Re: River Mist/ Woller Ranch MDP # 757

The City Staff Development Review Committee has reviewed River Mist/ Woller Ranch Master Development Plan M.D.P. # 757. Please find enclosed a signed copy for your files. Your plan was conditionally accepted please note the following:

RIVER MIST/WOLLER RANCH
MASTER DEVELOPMENT PLAN

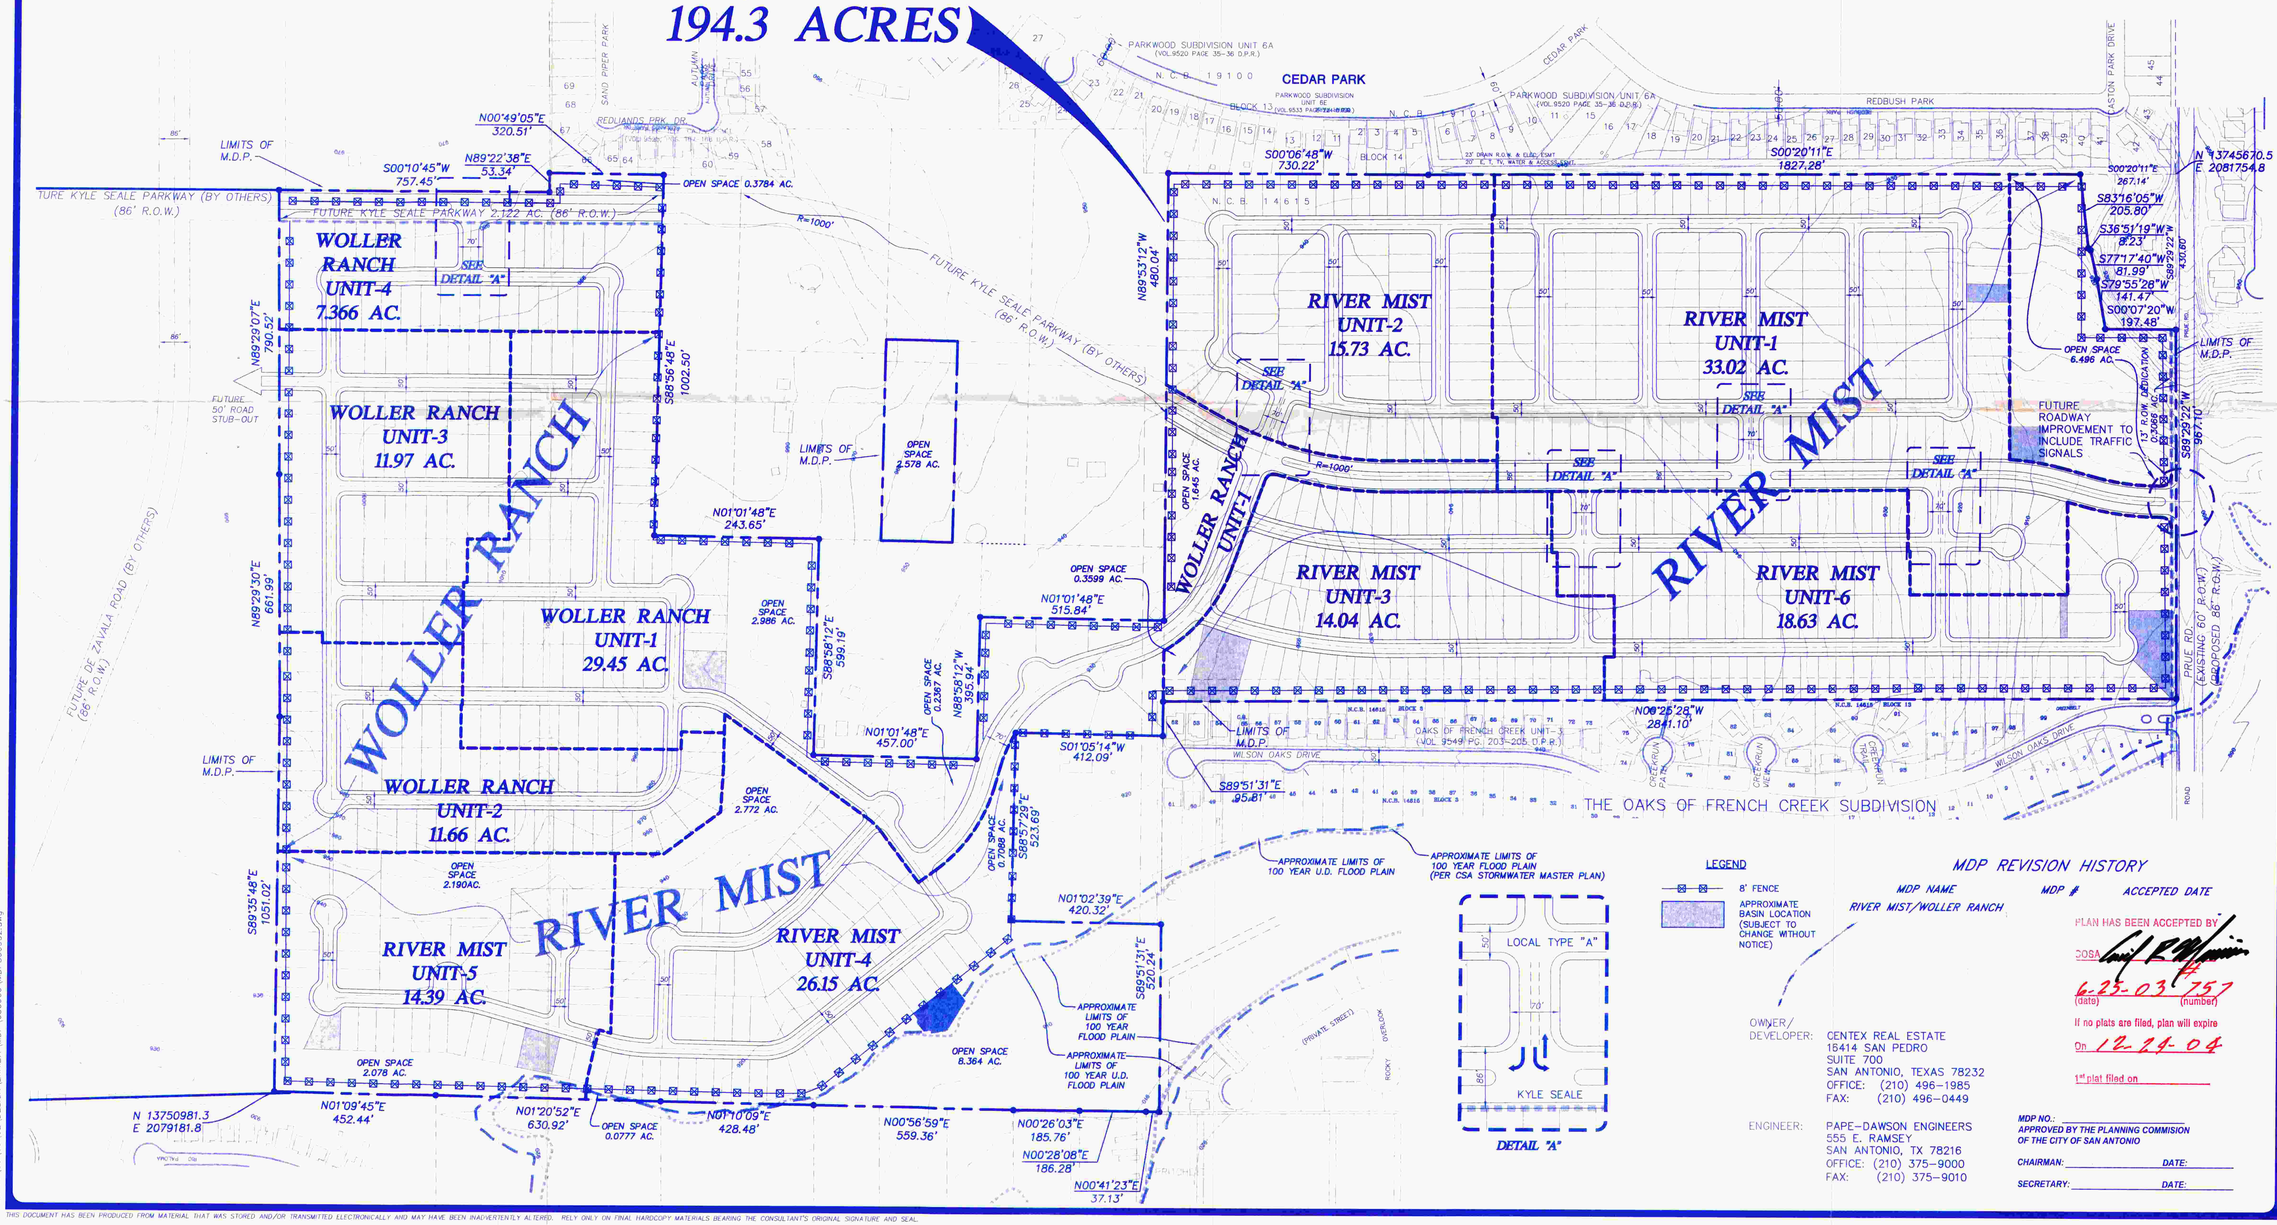
- Kyle Seal Parkway - Dedicate 86-feet of ROW and construct a 4-lane divided roadway (Secondary Arterial Type B). The limits of construction shall be extended through the River Mist/Woller Ranch development as shown on the City of San Antonio Major Thoroughfare Plan.

- The Developer shall provide 43 feet of ROW from the centerline of Prue Road adjacent to this proposed project. This will require a property dedication by the developer.

- Construction of an internal collector street system. Collector streets with 70-feet of ROW and 44-feet of pavement shall have no houses fronting.

- The developer shall be responsible for upgrading the intersection of Kyle Seal Parkway and Prue Road as shown on the approved Master Development Plan. This includes sufficient left-turn storage, right-turn deceleration lanes, upgrading lane capacity on Prue Road and a traffic signal when warranted.

- All proposed median openings on Kyle Seal Parkway shall provide sufficient left – turn storage. For tee – intersections on Kyle Seal Parkway the median shall provide a bullet nose design as described on page 701 of 2001 AASHTO Policy on Geometric Design of Highways and Streets (AASHTO Green book).

- It is recommended at the intersection of Woller Ranch Unit-1 and River Mist Unit-2 that right turn deceleration lanes be provided due to the fact that a traffic signal may be warranted

- in the future. This intersection provides adequate spacing from the intersections of Prue Road at Kyle Seal Parkway and the future intersection of DeZavala Road at Kyle Seal Parkway.

- Stub – out for Unit 3 Woller Ranch shall be placed in accordance with the design of De Zavala Road. The sub-out location could vary toward the west due to traffic at the future intersection of Kyle Seal Parkway and De Zavala Road.

- Eye – brow design for Unit 1 Woller Ranch shall be a 50 – foot radius curve. There shall be no driveways and or houses fronting collector street (70 – feet ROW, 44 – feet pavement) on Unit 1 Woller Ranch.
